ORIGINAL SPECS.  
& Addenda

CITY OF WINNIPEG  
WILKES AVENUE PUMPING STATION  
WINNIPEG, MANITOBA

REF. ADDENDA NO 1.

PRECAST CONCRETE DETAILS

COPING DETAIL

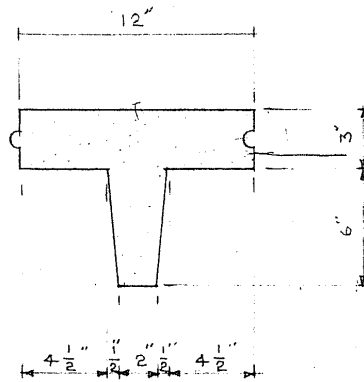
- a) Item M:3:6. All surfaces to be caulked with thickal base sealant shall be primed with special primer designed to seal porosity in concrete around joints and to increase bond between sealant and concrete.
- b) All precast wall panels shall be pre-stressed to provide 500 p.s.i. on concrete. - Item M:3:2.
- c) Item M:4:3 (c) - add "after first applying special primer specified in strict accordance with manufacturers recommendations.  
Add:
- d) Supply to excavating trade for installation precast 6" flexicore slabs complete with dowels for underground electrical service duct.
